UNITED STATES PATENT AND TRADEMARK OFFICE

APPLICATION NO.	FILING DATE	FIRST NAMED INVENTOR	ATTORNEY DOCKET NO.	CONFIRMATION NO.
10/535,137	01/25/2006	Leif Andersson	15090NP	3586
<div>293 7590 07/09/2007</div> <div>Ralph A. Dowell of DOWELL & DOWELL P.C. 2111 Eisenhower Ave Suite 406 Alexandria, VA 22314</div>				
			EXAMINER	
			COOLEY, CHARLES E	
			ART UNIT	PAPER NUMBER
			1723	
			MAIL DATE	DELIVERY MODE
			07/09/2007	PAPER

FINAL OFFICE ACTION

FIG. 3

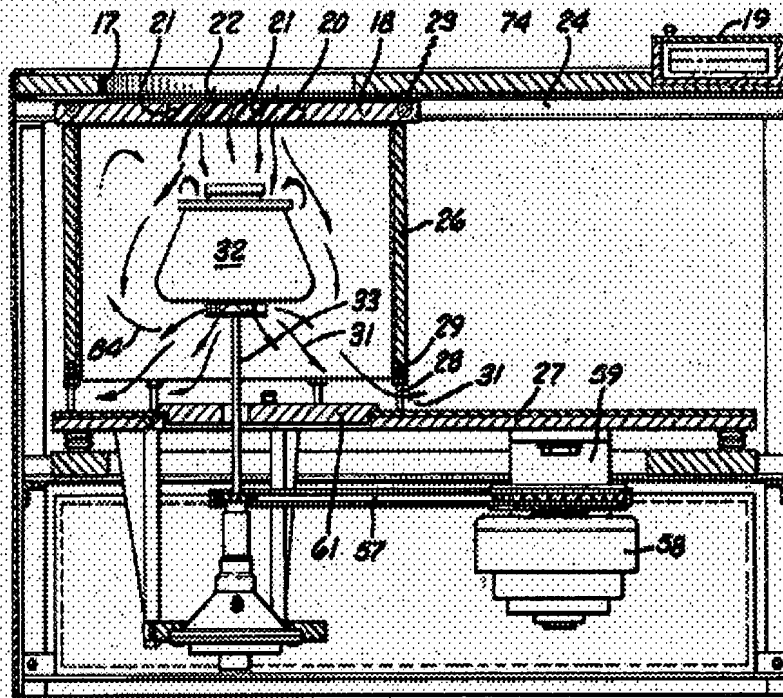
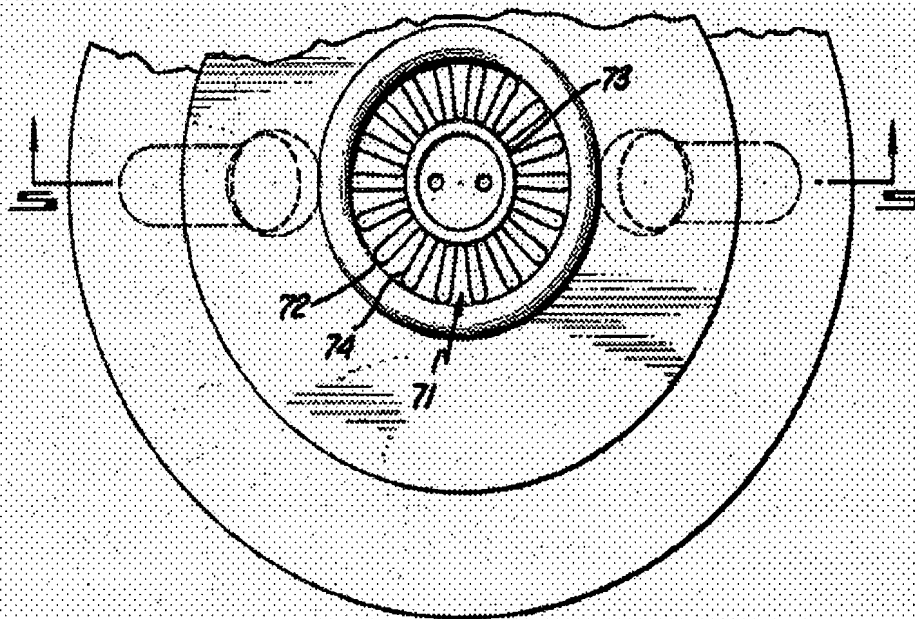
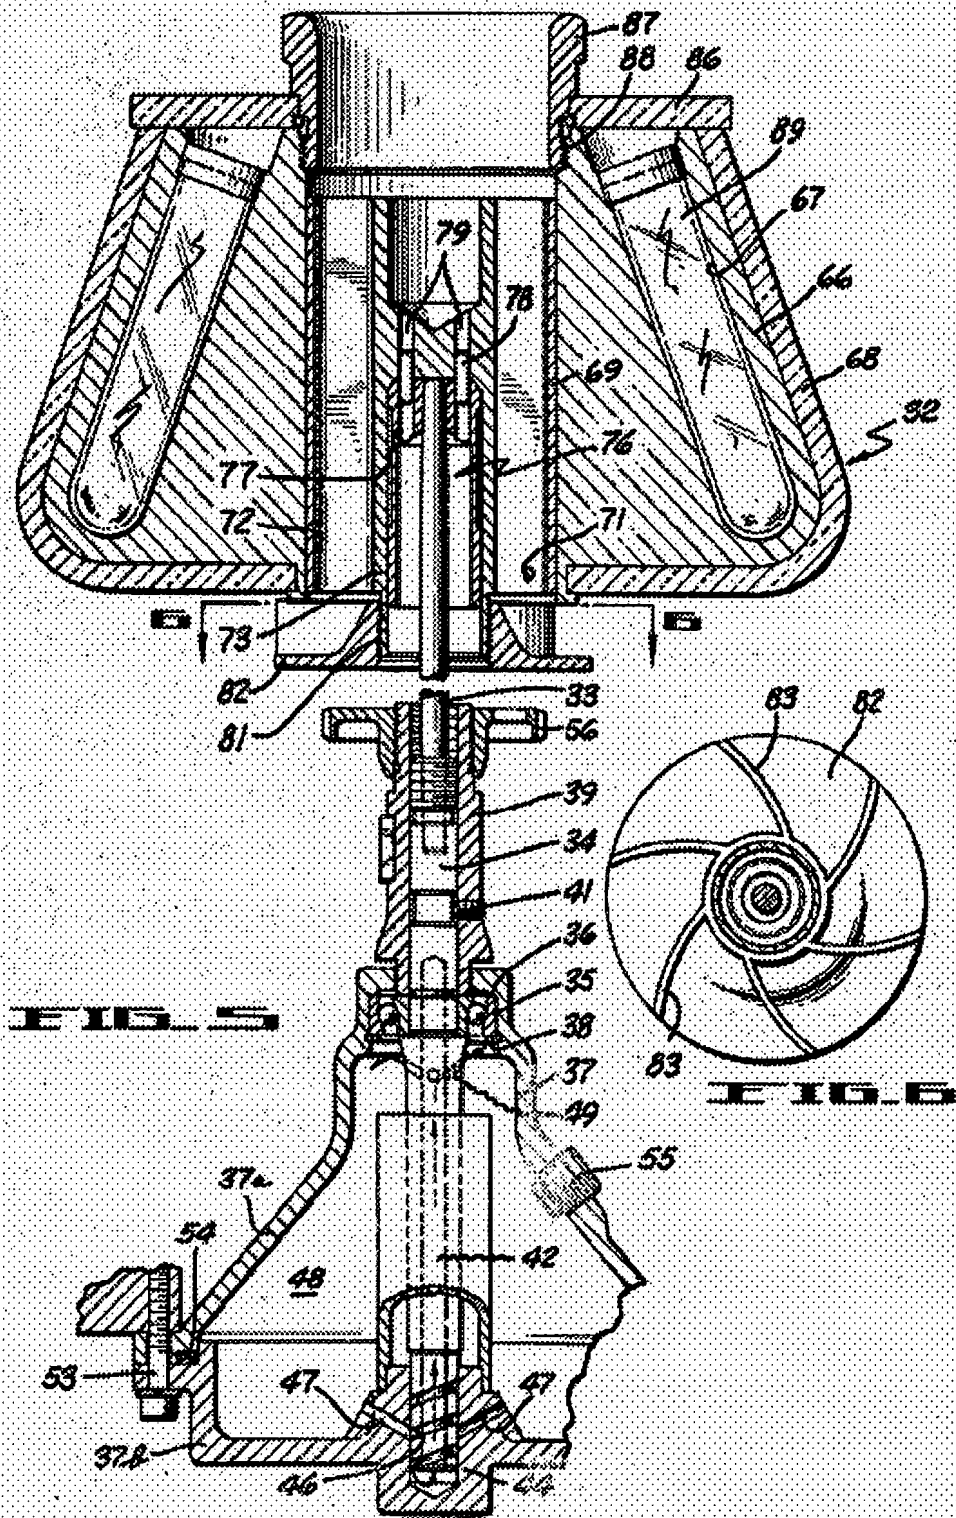
The patent to Pickels et al. discloses as seen below a device for centrifuging including rotor means 32 with thermal treating means for thermally treating centrifuging reaction vessels 89 containing samples in a thermocycling device; the rotor means 32 comprises at least one fan blade 71 and/or 83 which force ambient gas to through the rotor means and pass in heat exchange relationship the samples (e.g., to cool the rotor and inherently the contents or samples therein - col. 3, lines 20-22); at least one gas conducting passage 69 is arranged in the rotor means 32; wherein the rotor means 32 comprises a base portion (above 82) and a lid portion 86, 87, in between which an inner space 69 is formed wherein the fan blades 71 and/or 83 are arranged; the lower region of the rotor means 32 is provided with at least one through hole (above 82); the upper region of the rotor means 32 is provided with at least one through hole 87; the fan blades 71 are arranged at the inside of the base portion of the rotor means 32; wherein the fan blades 71 are arranged at the inside of the lid portion 86, 87 of the rotor means 32; a plate 86; the gas is ambient air (col. 3, lines 41-49).

The blades 71 and 83 of Pickels can be termed "fan blades" within the broad scope of the term since these blades are set into motion via rotation of the rotor means and directly contact and thus influence movement/impelling of the ambient air, at least to some degree. Since the blades 71 are in contact with the rotor, these blades function to impel the movement of air (again, at least to some degree by the impact between the rotating blades 71 and the surrounding air) and act as heat exchange blades/fins as well to cool the rotor. Hence, Applicant's conclusion that the blades in Pickels are not equivalent to the very broadly recited fan blades is not a compelling argument.
